COMMITTEE OF THE WHOLE - APRIL 10, 2001

**ZONING BY-LAW AMENDMENT APPLICATION
SITE DEVELOPMENT APPLICATION
REPORT #P.2000.95
TRULLWROOK INVESTMENTS LIMITED (CANADIAN TIRE STORE)
FILES: Z.00.086 AND DA.00.086**

ATTACHMENT '2'
SITE PLAN

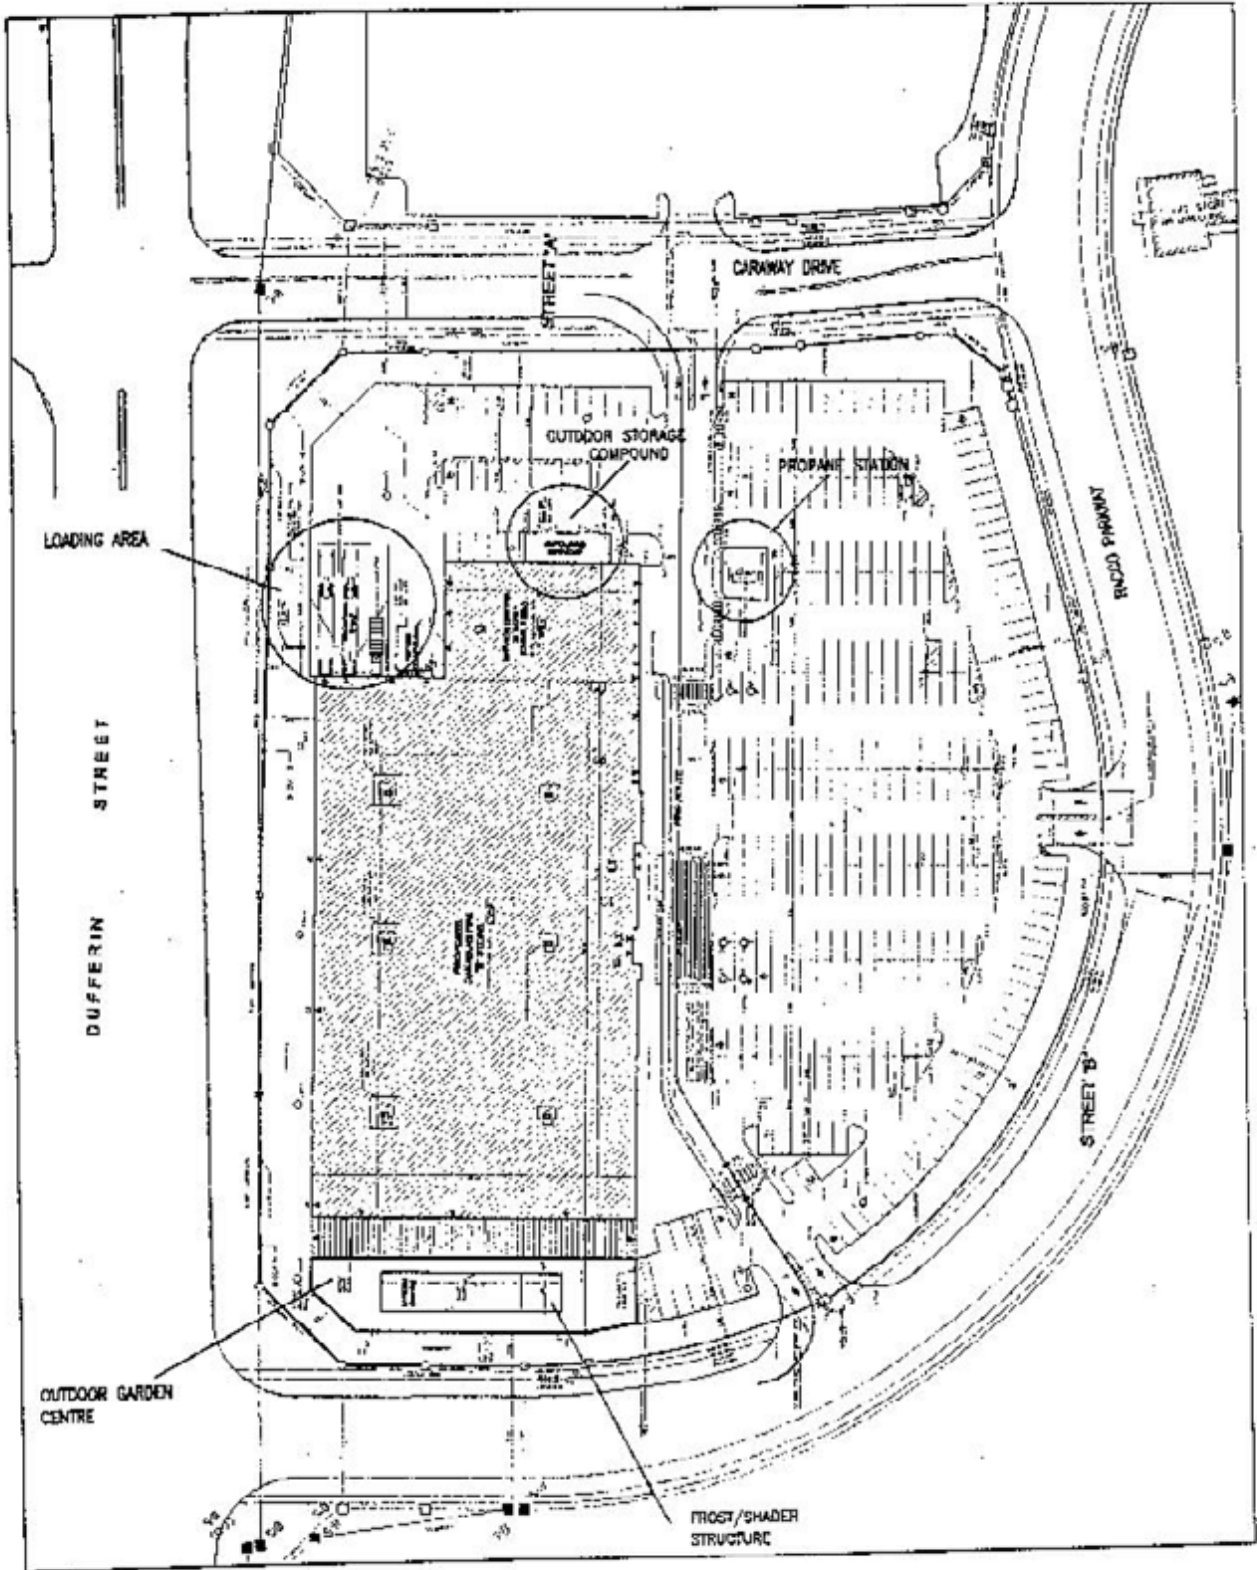
The Urban Design Department requires a significant number of painted traffic islands within the parking area to be changed to curbed landscaped islands, resulting in 5 less parking spaces and relocation of a cart corral. Given the conclusions of the parking report, this deficiency is acceptable, as the site will benefit by a more visually acceptable parking area.

The 9.14m high pylon sign adjacent to the loading screen wall must be relocated further south, and away from the subdivision entry features. Also, the site servicing and grading plan must be revised to relocate the hydro easement away from the northeast corner of the site, as it conflicts with the landscape features identified on the Master Landscape Plan.

ATTACHMENT '3'
LANDSCAPE PLAN

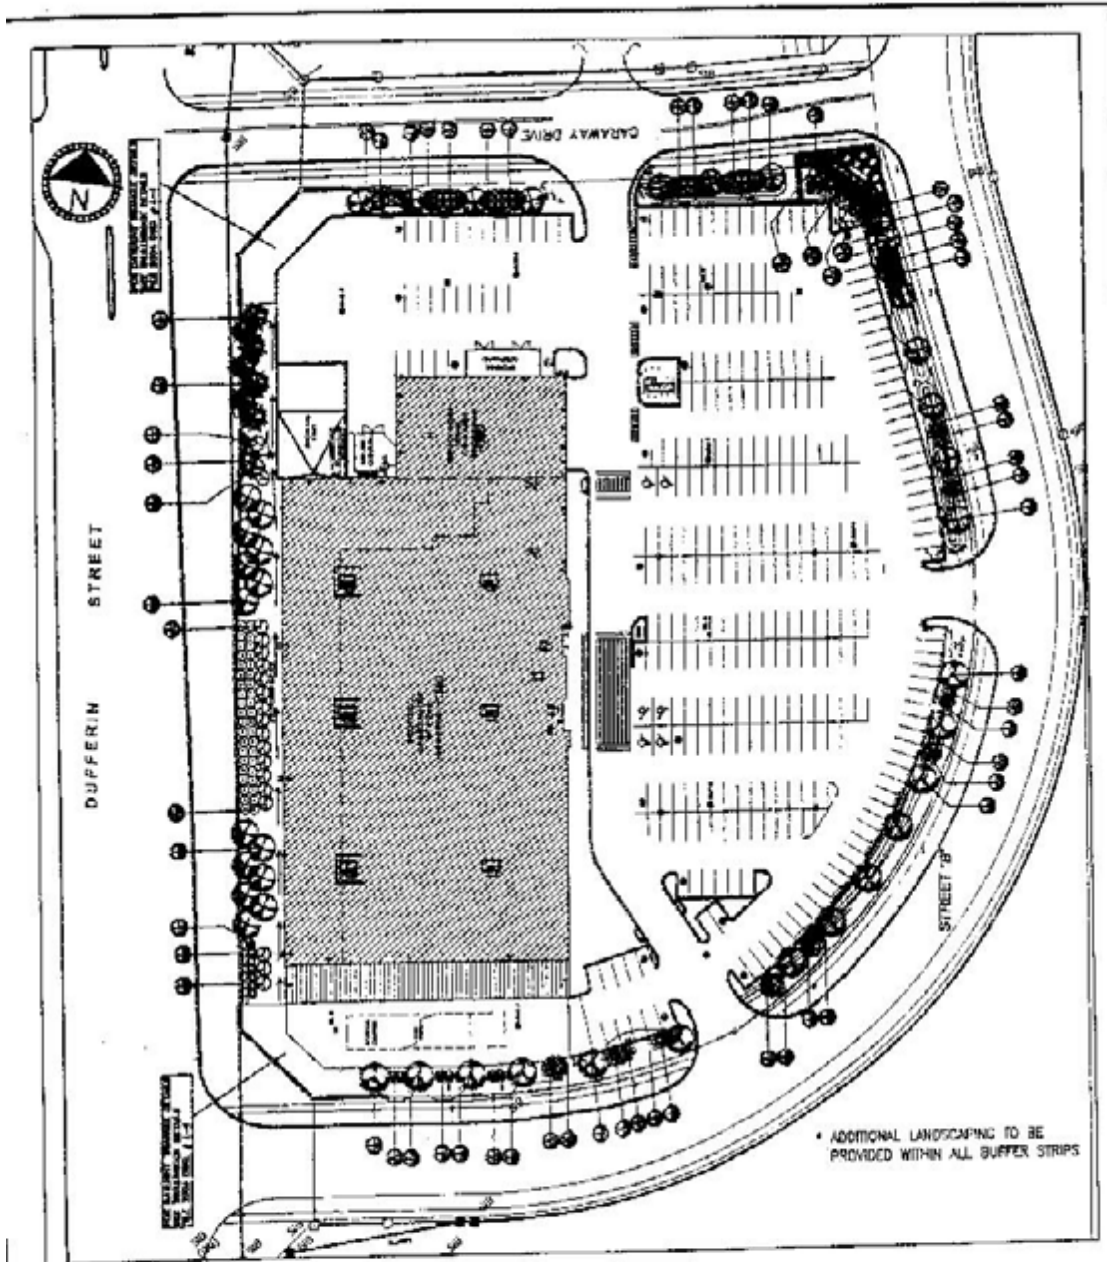
The landscape plan consists of deciduous and coniferous tree and shrub planting around the perimeter of the site. A 9m wide landscaped strip will be provided along Dufferin Street, and a 6m wide strip will be provided along Caraway Drive and Racco Parkway. Staff can support the proposed reductions to the landscape strip widths at the northwest corner of the site from 9m to 7.6m and 8.1m, and to 7.5m at the southwest corner, which will not compromise the streetscape in these locations. As compensation, the planting will be enhanced and in of the landscaped strips on the site.

Decorative unit paving is proposed within the parking lot and provides a pedestrian connection from Caraway Drive, across the front of the building, and terminating adjacent to the enclosed garden centre. The landscape plan must be revised to show the southerly extension of the pedestrian connection to Racco Parkway, curbed landscaped islands and the relocated cart corral. The curbing around the propane fueling station needs to be extended westward, and include depressed curbs for pedestrian connection. Also, the grading along Dufferin Street must be revised to accommodate a level area with a swale adjacent to the building, and to allow sufficient room for the entry features identified in the Master Landscape Plan.
